**RE: Lot 6 – 3151 Bridge St. SW
Grading and Drainage Plan
Engineer's Stamp Date: 02/28/23
Hydrology File: L11D067D**

Based upon the information provided in your submittal received 02/28/2023, the Grading & Drainage Plan **is not** approved for Building Permit. The following comments need to be addressed for approval of the above referenced project:

GRADING & DRAINAGE PLAN

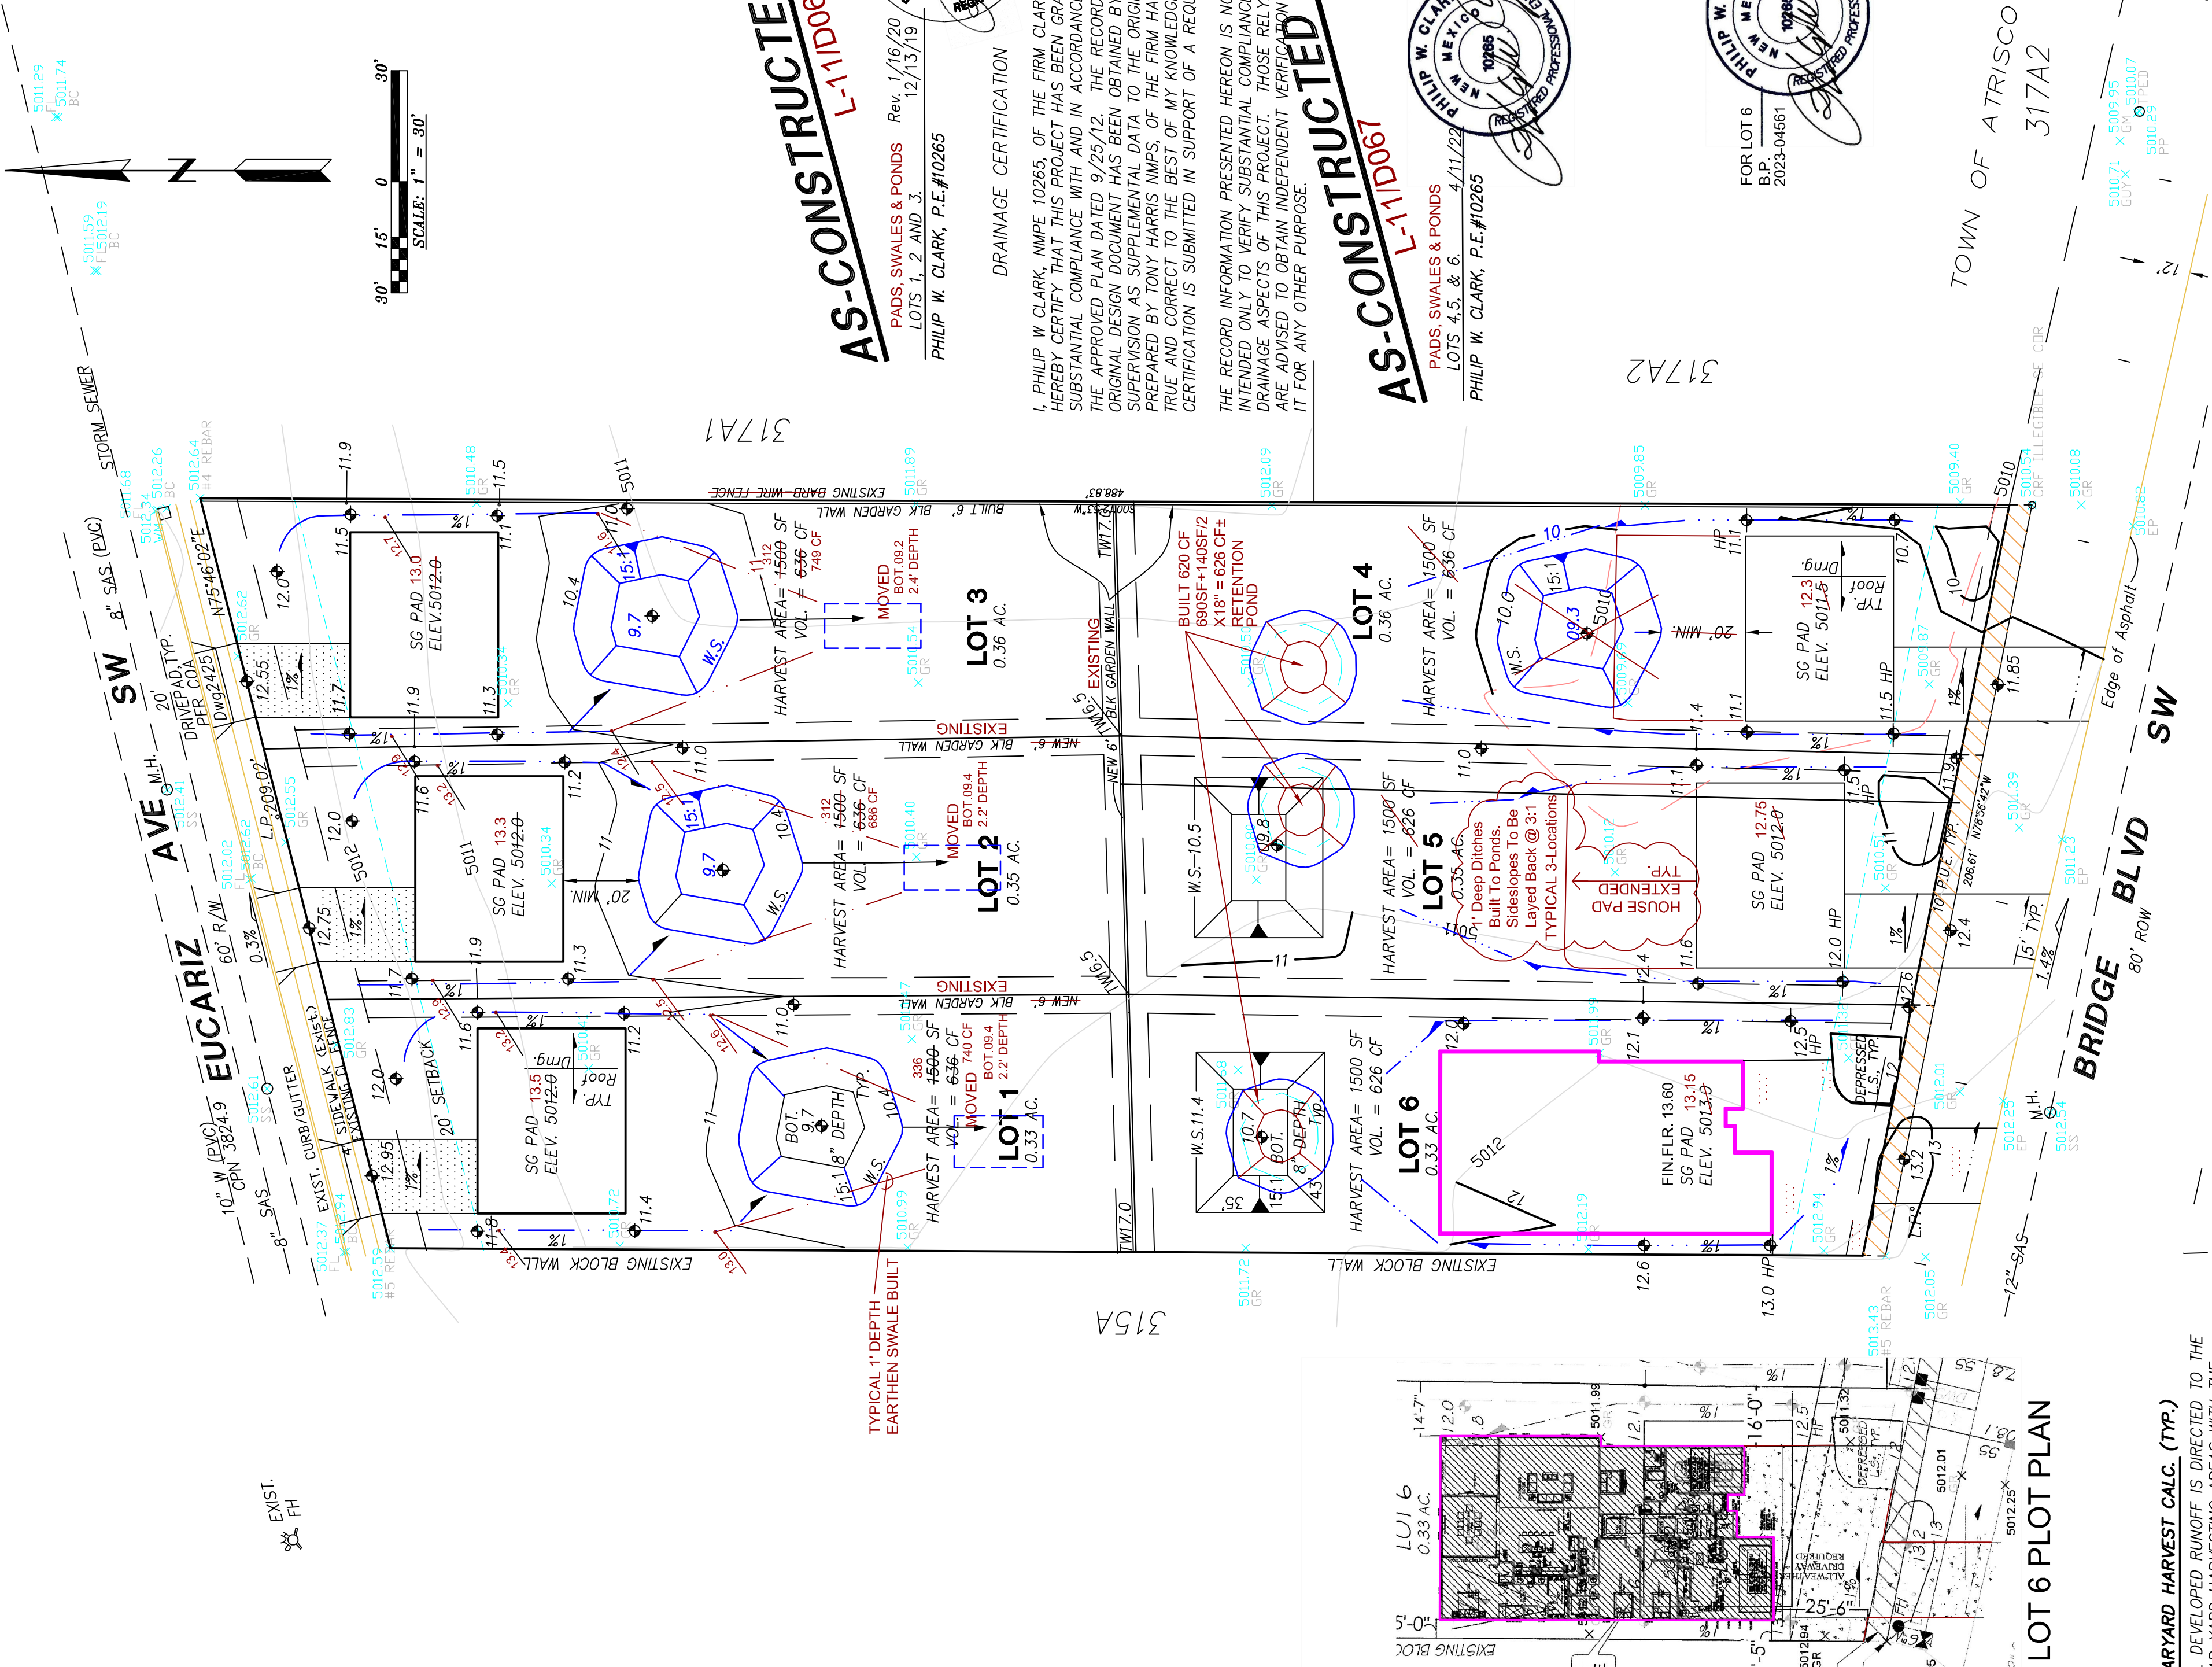
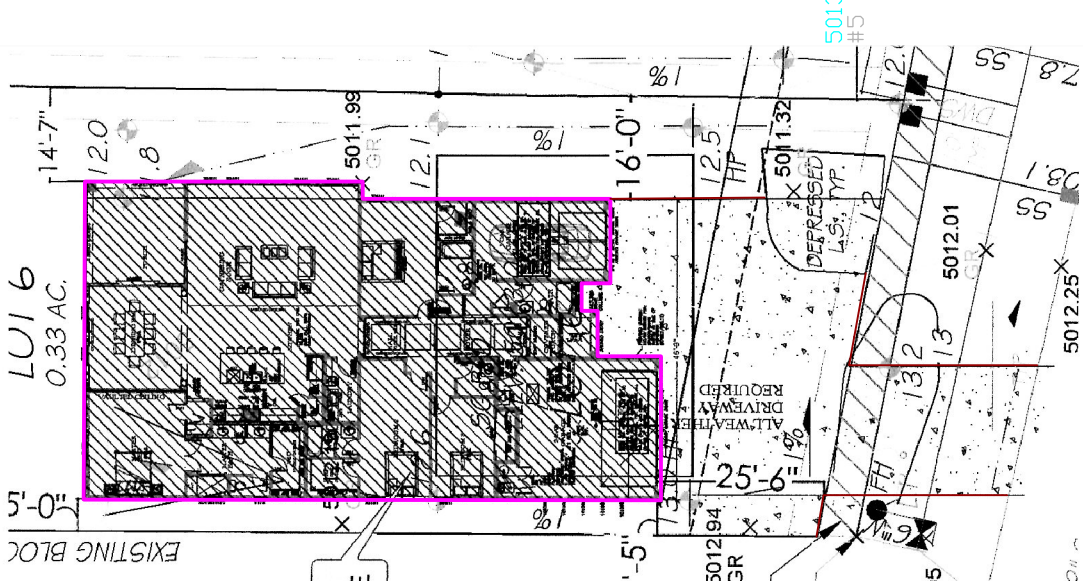
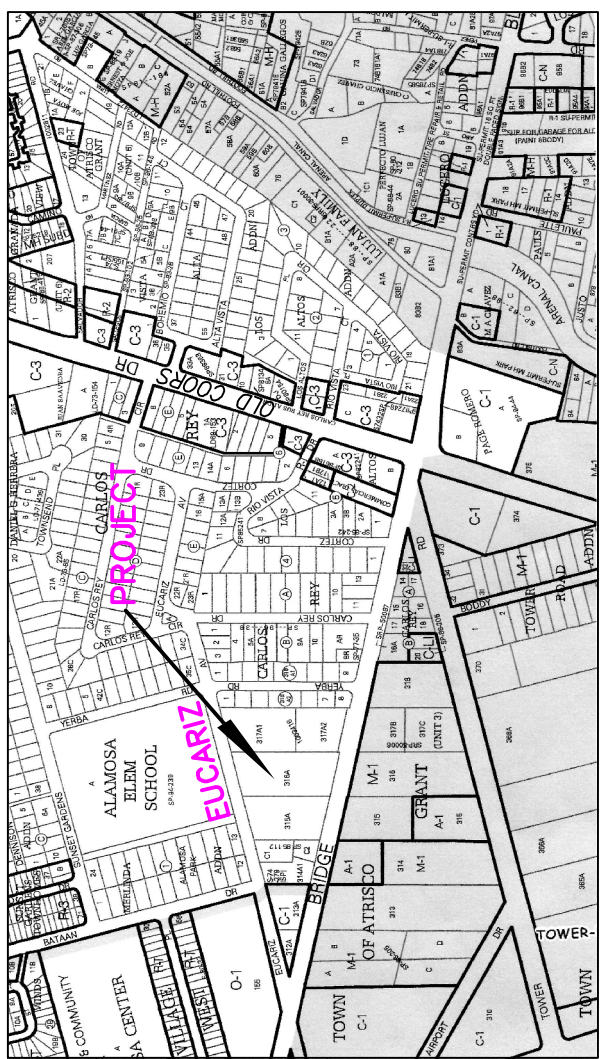
1. This entire subdivision has been modified from the approved Lots 1-3 Pad Certification approval given on January 21, 2020 of which as-built certification & Permanent Certificate of Occupancy approval by Hydrology was never issued for each of these Lots. After Lots 4-6 Pad Certification approval was given on April 15, 2022, there was major grading done on these lots which can be seen on the aerial below. Therefore, Hydrology request a new as-built survey for Lots 4, 5, & 6 be done and shown on the submittals for these Lots for Building Permit. Also, please just show each lot separately with current drainage calculations that adhere to Chapter 6 of the current DPM. Remember for Lot 6, the retention pond required will be the proposed house and driveway impervious area for the 100 year – 10 day volume as outlined in Article 6-5.

2. Since this site is in the Valley region, please follow Article 6-5 Valley Drainage Criteria of the DPM. The following conditions must be applied to the site:
 - a. The maximum percent impervious of the lot and the contributing area may not be greater than 45%.
 - b. Pad elevation shall be a minimum of one (1) foot above the 100 year 10-day stormwater surface elevation.
 - c. The flow between the front yard and back yard cannot be obstructed. The stormwater must be allowed to equalize to the same level between the front yard and back yard.
 - d. A permanent perimeter wall or barrier around the development is required to contain the 100-year 24-hour storm developed runoff.
